Penrith Accessible Trails Hierarchy Study (PATHS) Feedback

Thank you for the opportunity to comment on the Penrith Accessible Trails Hierarchy Study (2022-2032).

These comments have been prepared on behalf of CAMWEST, a Bicycle NSW affiliated Bicycle User Group with a focus on advocating for and encouraging cycling in Western Sydney. Our focus over the last 15 years or so has primarily been in the Blacktown, Parramatta, and Cumberland Local Government Areas. However, with no formal Bicycle NSW affiliated group representing the Penrith LGA and with CAMWEST members and associates living in the council area, we would now like to take a more proactive role in engaging with Council and encouraging cycling in the LGA.

Red lines - Known shared paths which don't appear to be marked on the 'base maps' as existing paths.

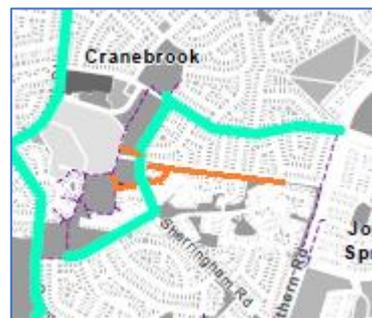
We have questions relating to the 'existing' paths on the maps included in the PATHS documentation.

The map on the right shows some existing paths in red which we use that aren't displayed on the base map – although some of the text in the main document refers to portions of them.

We're also aware of paths around Jordan Springs and Claremont Meadows that aren't shown on the base maps.

No kerb ramp from pathway to Pendock Rd roadway.

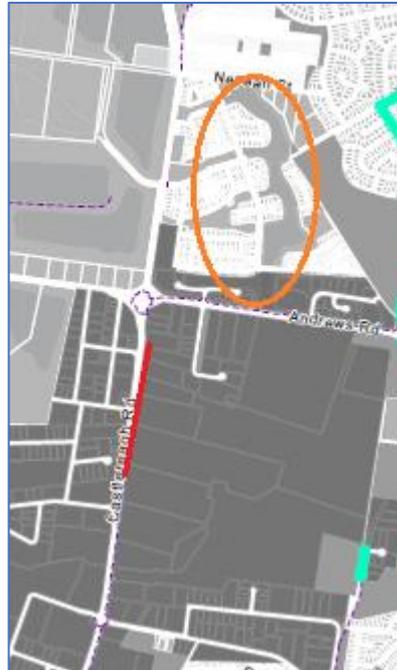
There are other paths marked that were previously unknown to us. The main orange marked path between Sherringham and Pendock Rds starts off as 1.8m wide at the Sherringham Rd end, before widening to 2m. There are no direct kerb ramps at either end (see photo below). The path looks like it could extend through the reserve to the shared path alongside The Northern Rd, but doesn't.

Ignoring the furniture in this photo, there are no kerb ramps (or driveways nearby) from this marked shared path onto the Pendock Rd roadway.

The other end of this pathway has offset kerb ramps to Sherringham Rd roadway, but no direct link to the marked shared path on the other side. There is a branch path which has a zebra crossing and improved kerb ramps.

Red line – continuation of 2m wide path along Castlereagh Rd to the service road near the Andrew Rd roudabout.

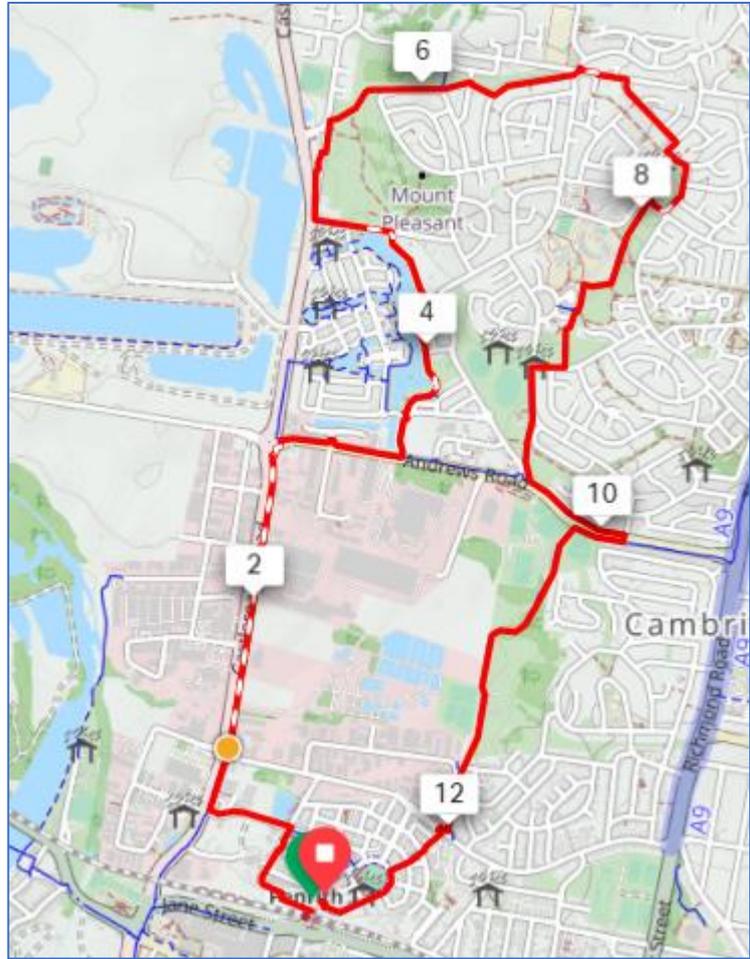
As the path alongside Castlereagh Rd heads north from Penrith CBD, it narrows to 2m up until the service road just before the Andrews Rd roundabout (apart from a narrower section out front of the Ampol Service Station near the Coreen Ave roundabout).

Part of this 2m wide section is marked as existing path, but the section in red on the map to the right is not marked. We are curious as to why.

There are paths around the 'Lakes Walk' (in the orange circled area) which are 2m wide but not marked as shared paths – which would act as a great connection between the Andrews Rd shared path and the path beginning on the corner of Nepean St and Castlereagh Rd.

Note that as Toni Bracher pointed out in her comments to council, the crossings of Coreen Ave and Andrews Rd beside the dual-lane Castlereagh Rd roundabouts can be quite dangerous.

In general, we think pedestrian/cyclist crossings should be moved away from these types of roundabouts.

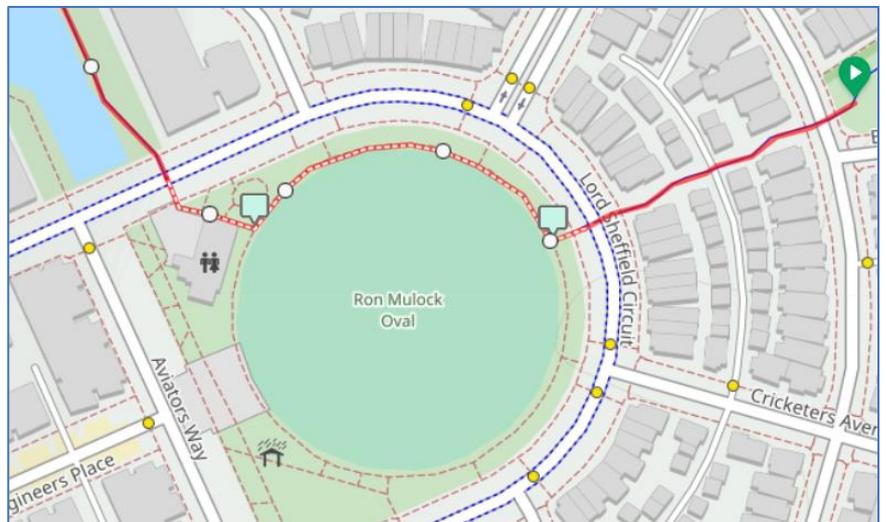
We'd love to be able to promote cycling in the Penrith area by putting a route like this as one of our 'self-guided' routes, but feel unable to at present as some of this route is along 2m wide paths that don't appear to be recognised by council as shared paths.

CAMWEST seeks clarification from council on:

- Whether the existing 2m wide path along Castlereagh Rd as far as Andrews Rd is officially a shared path (noting that the whole of Castlereagh Rd is a proposed Regional Route with presumed width of at least 2.5m);
- Whether council are prepared to recognise all or some of the 2m wide paths around the Lakes Walk (above) as shared paths.
- Whether the path around the Ron Mulock Oval (Penrith) is a shared path. For example, is what's marked on the map legal, or do riders need to traverse this route on the Lord Sheffield Cct roadway?

Is the path around the oval actually a shared path?

Marked-up Google Streetview image of the intersection. Red lines represent current shared paths, orange circled area shows the corner in question.

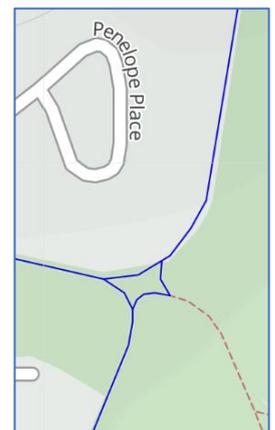
- Widen the path at the NE corner on the intersection of Thornton Drive and Combewood Ave Penrith (or via other means) to better indicate the crossing of the shared path at this intersection.

4-way intersection in reserve behind Penelope Pl, with no path to go 'straight-ahead' in either direction.

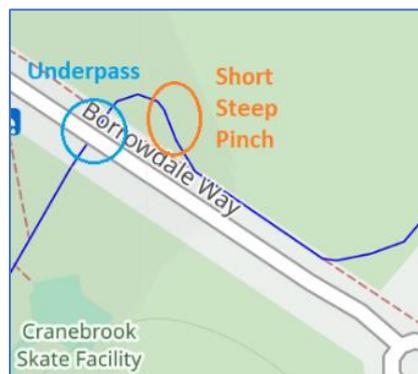
- Redesign of the '4-way' intersection in the reserve behind Penelope Pl, Cranebrook, where there is no direct path to go either north-south or east-west. CAMWEST are not generally in favour of 'cross' intersections. If possible, offset T intersections may be a better option in this instance.

Current stairs with ramp

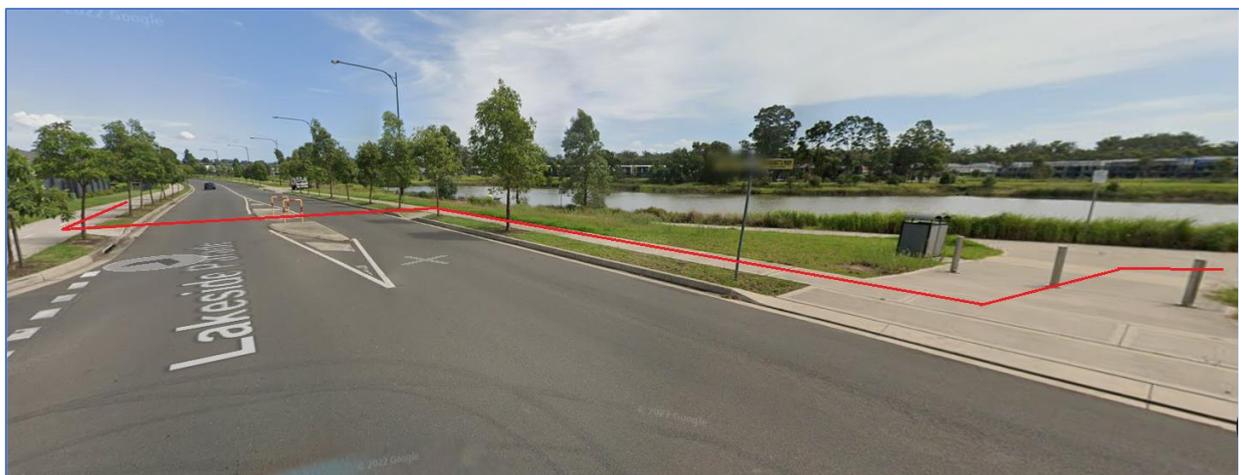
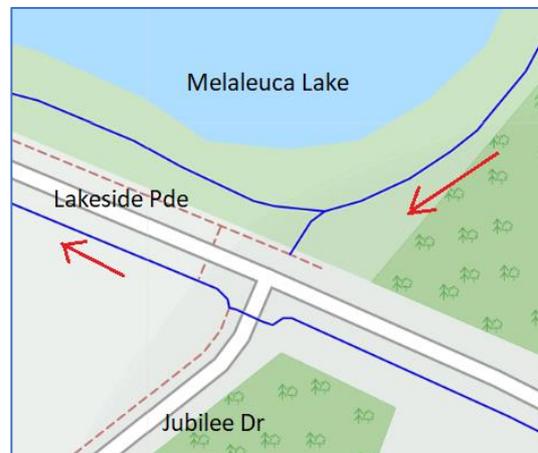
- Ignoring all the sediment currently at the bottom of the stairs off Nepean Ave down to the northern section of the River Walk, improved access for bikes to this area would be strongly desirable. A ramp would be much easier to navigate from a rider's perspective and allow access for other wheeled modes of transport.

If not feasible, some means of helping keep a bike on the narrow ramp area, like a channel or even a pipe-barrier as shown in these photos, would be an improvement.

Proposed 420m path widening along Werrington and Rance Roads, Werrington.

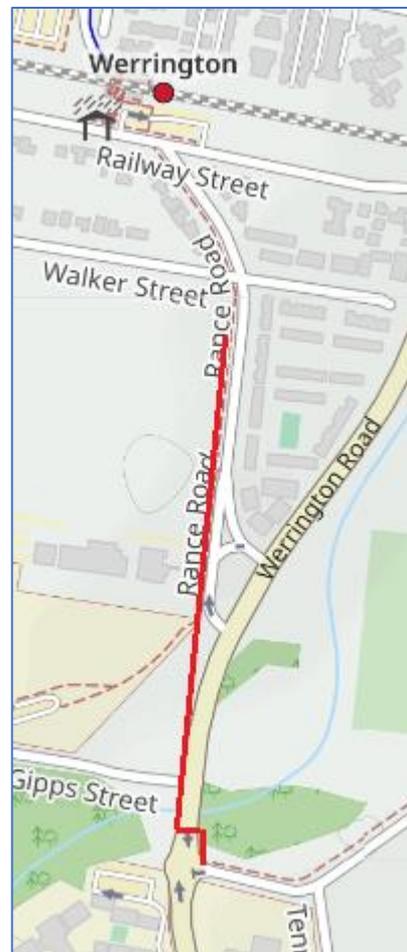
There are currently two ways of crossing the railway line at Werrington:

- Ride along Werrington Rd, where the road shoulder disappears to almost nothing across the railway bridge. There is a path on the western side of the bridge, but this is not readily accessible from the roadway.
- Walk across the Werrington Station overbridge, and ride along Rance Rd. If travelling north to south, a right turn needs to be made from Rance Rd onto Werrington Rd, which can be tricky.

We note there is a proposal to realign this section of road under the [Werrington Arterial Stage 2](#). We would request that north-south and east-west connectivity for riders be implemented during this upgrade.

In the interim, we feel that safety for cyclists could be improved if a section of the current footpath alongside Rance and Werrington Roads were widened to shared path width. This would allow cyclists travelling south to cross Werrington Rd at the existing traffic island just north of The Kingsway roundabout, and continue either into The Kingsway or down Werrington Rd towards the Great Western Hwy.

250m section of missing shared path in red circled are along Greenwood Parkway, Jordan Springs.

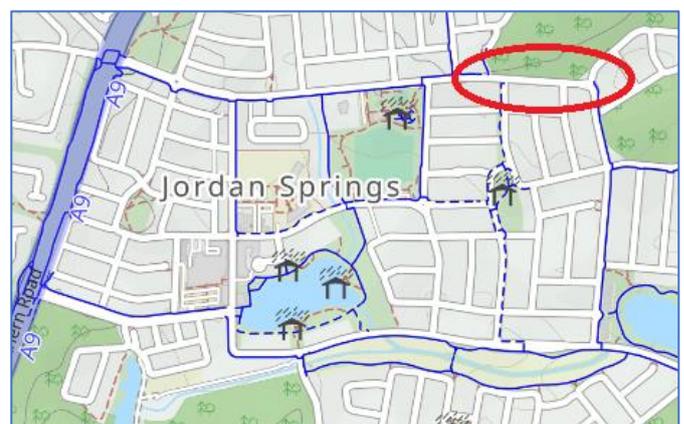
- Jordan springs has quite a good shared path network around and within it. There is however one 'missing' 250m section along Greenwood Parkway. I'm unsure why, but this section is a narrower footpath rather than the designated shared path which encircles the remainder of the suburb. I imagine that this was funded and constructed by the suburb developers.

Do Council have any explanation as to why and/or leverage with the developers to request conversion of this segment to shared path width?

Proposed route from existing Cranebrook shared path off Lord Sheffield Cct to Penrith Station. The other shared-path alongside Thornton Canal can also link in near the Restrooms.

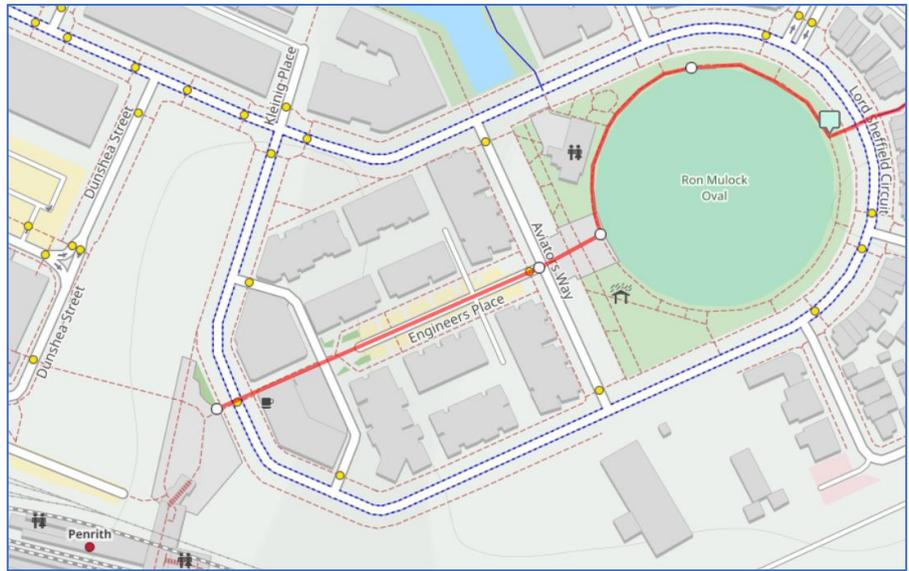
- If the wide path around the Ron Mulock oval is considered a shared path (as asked above), would it be feasible to create the following route to the Penrith station forecourt?

A kerb ramp would be required from the oval path to Aviators Rd roadway, and then some kerb ramps and concrete for the few metres from the end of Engineers Place to the laneway behind Quest Penrith.

Marked-up Bing aerial image of footpath across Boronia Park, St Marys.

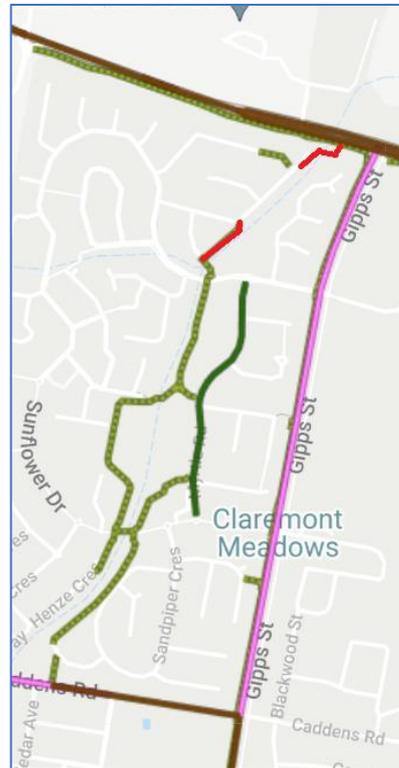
- There is currently a concrete footpath that links the shared path on the Blacktown LGA side of Ropes Ck across Boronia Park to a rough car parking area off Boronia Rd (near the Athel St intersection).

Particularly when Local Priority Routes 5 & 7 from North St Marys to St Marys Station are constructed, widening this path and finishing to Boronia Rd could form another important link.

Paths along the Claremont Ck corridor through Claremont Meadows

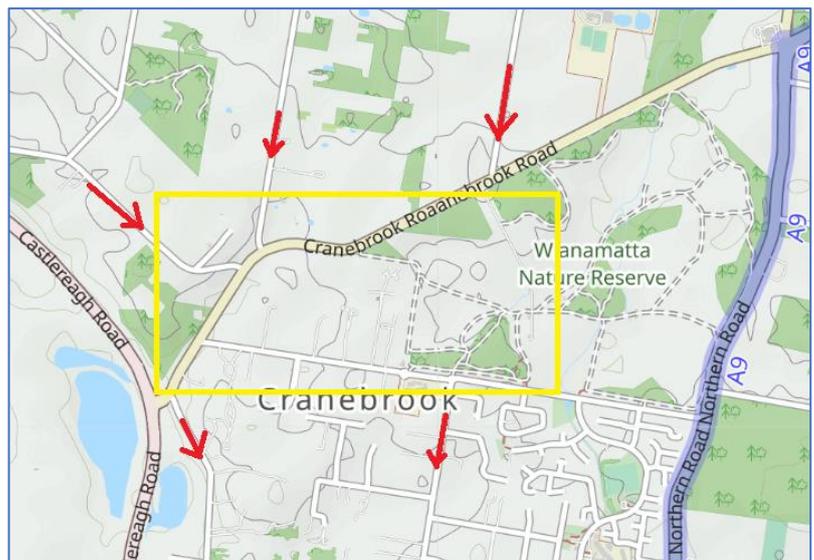
- These paths along the Claremont Creek corridor between the Great Western Hwy shared path and Caddens Rd in Claremont Meadows don't appear on the base maps. Some have shared path signage up.

We note that this corridor is mentioned as Project 25 in Table B.2 'Potential Local Routes and Projects'. Rather than all the sections mentioned in this project, it would appear to us that the sections marked in red which currently have narrower footpaths in place are the higher priority paths to upgrade. These sections are:

- Great Western Highway Shared Path to Mistletoe Ave (approx 140m), and
- Mistletoe Ave to Dahlia Pl (approx 125m).

Ways of getting around or through the yellow bordered area.

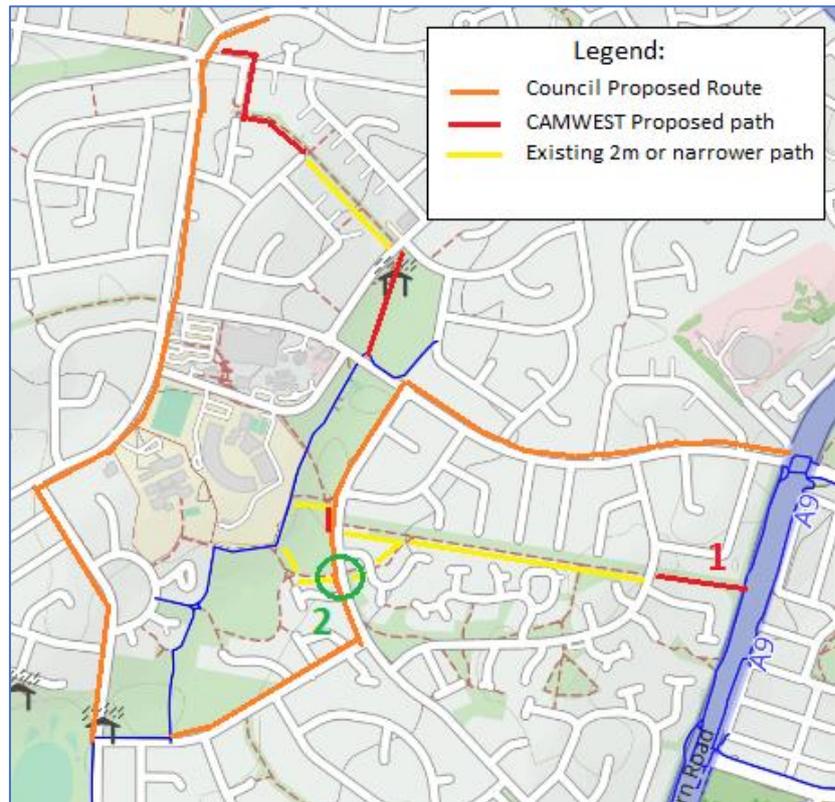
- We have had a dream of a safe route through from Church Lane, Tadmore Rd and/or Taylor Rd to either Cranebrook Rd near the Castlereagh Rd intersection or Grays Lane for a while.

I feel uneasy about riding along some parts of Cranebrook Rd between Taylor Rd and Castlereagh Rd, and probably wouldn't take a group of riders along this section.

We note that Project 23 of Table B.1 'Potential State Government Routes and Projects' is along Cranebrook Rd between The Northern Rd and Castlereagh Rd. This would be one solution, but is well down the priority list.

Another which we wish to investigate is through the Wianamatta Nature Reserve. We suspect this may be rideable in drier conditions. Are we correct in assuming that this parcel of land is managed solely by National Parks, and that Council doesn't have any direct say or control about what goes on within the boundaries?
